ICE SHIELD KIT

ICE SHIELD SUSTAINMENT KIT

Ice Shield Technical Drawings

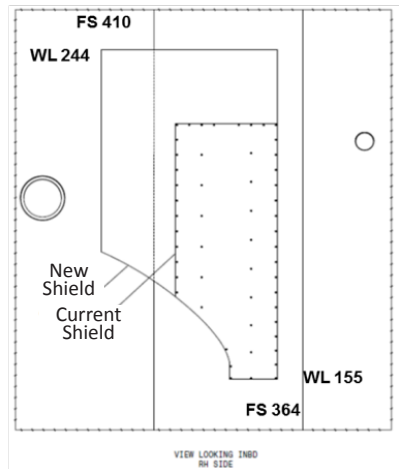
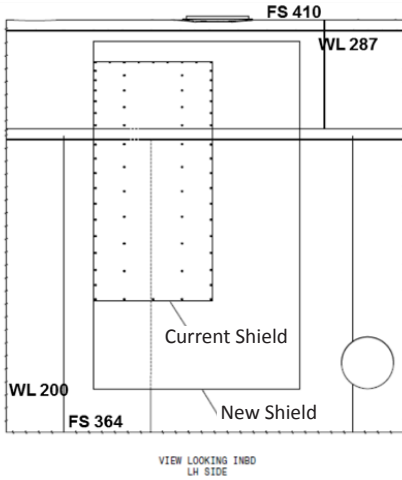
The improved Ice Shield will include a larger and thicker ice shield — 20 inches wider and 26 inches longer on the left hand side. The right is 20 inches wider and 27 inches longer, with both shields increasing in thickness from 0.040 to 0.071 inches of the same material and applies for fielded C-130J aircraft through Serial Number 5793.

Improved Ice Shield Kit: The upgrade kit consists of the shields, attaching hardware and detailed instructions for removal of the original shield and installation of the enhanced shield. The left hand shield has been divided into an upper and lower section to minimize cost and facilitate installation.
